SCHWEIZER SERVICE LETTER

L-160
14 Oct 1996

SUBJECT: STRUT AND BRACKET ASSEMBLY - BELT DRIVE INSTALLATION

MODEL AFFECTED: 269C Helicopters; S/N S-004 through S-1732

Figure L-160-1. Bracket and Strut Orientation

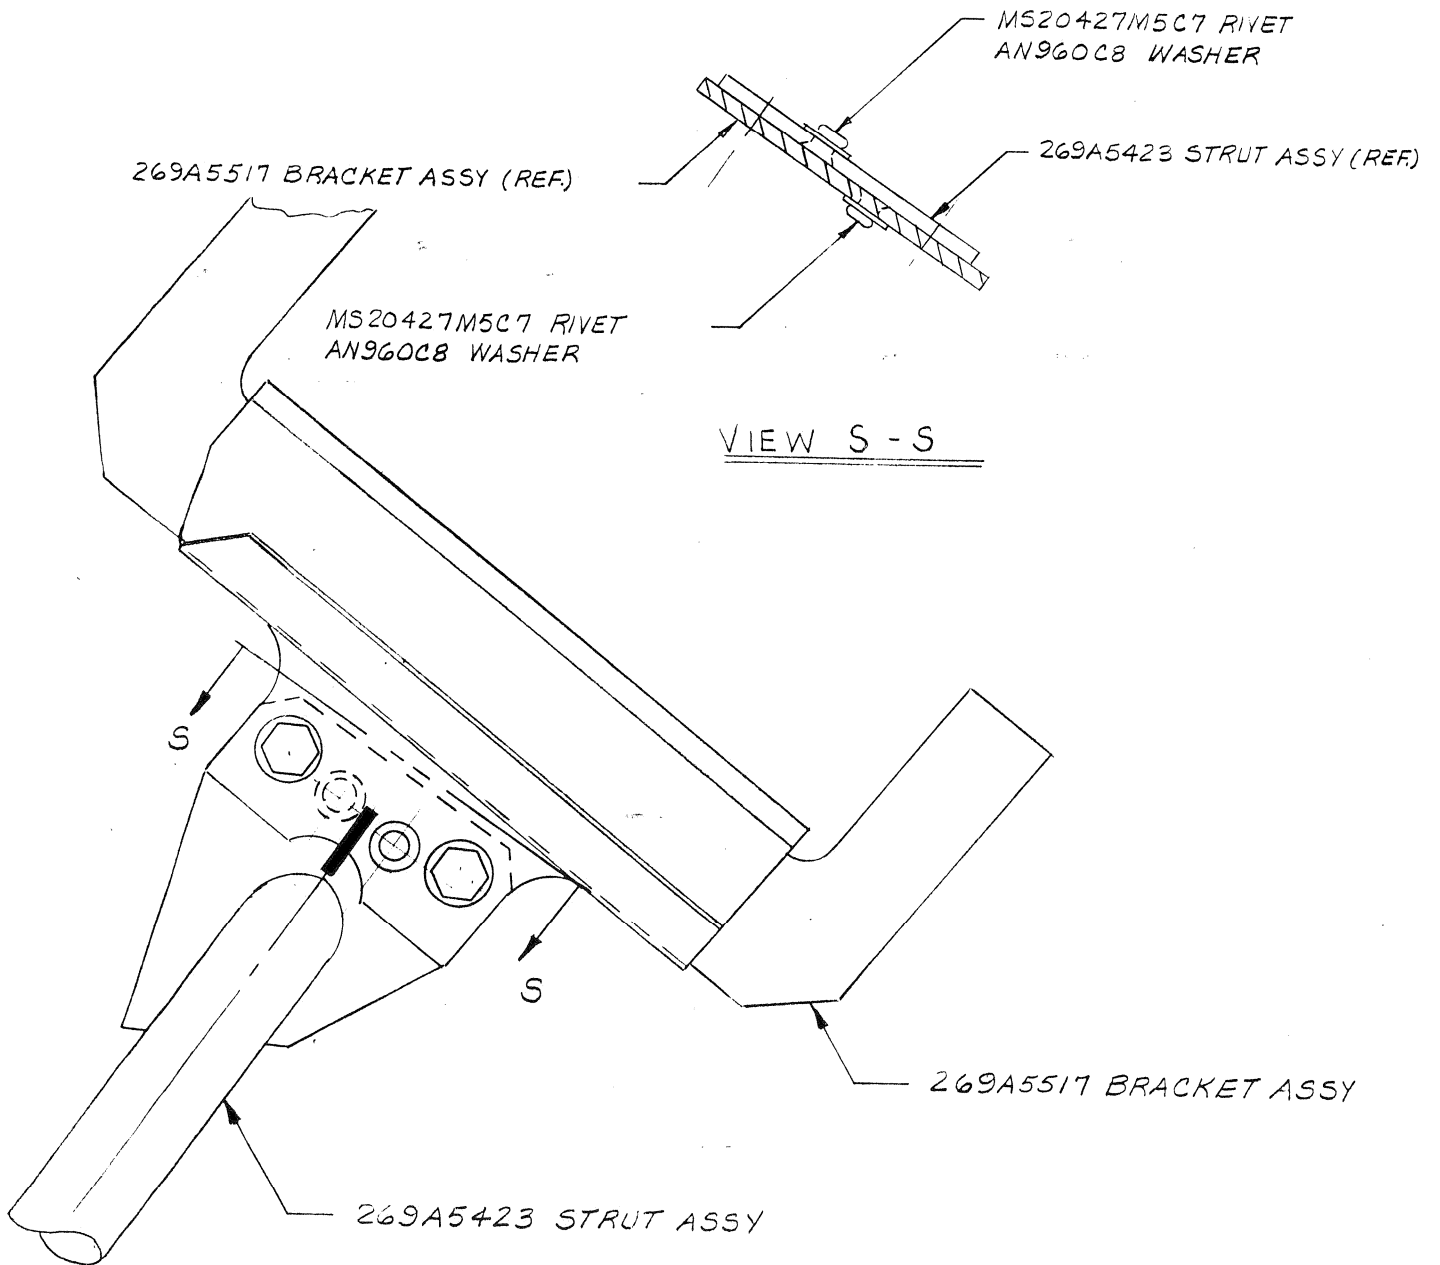
The 269A5423 strut assembly could be inadvertently reassembled incorrectly, in relation to the 269A5517 bracket assembly, after maintenance of belt drive system. The correct orientation of the strut, and attachment to bracket, is illustrated in Figure L-160-1 (Page 2 of 2).

- a. The strut is installed on top of the bracket.
- b. The strut is installed upside down (narrow side of attachment flange forward).
- c. The strut is installed upside down and on top of the bracket.

On helicopter S/N S-1733 and subsequent (and current spares) both bracket and strut have an arrangement to prevent disorientation of mating parts. As an option, the rivet and washer arrangement shown on Figure L-160-1 can be installed in the field.

If in doubt that the bracket and strut are assembled correctly, orientation should be checked for the conditions specified above. If assembled wrong, it is recommended that these parts be disassembled, inspected for cracks, and reassembled correctly.
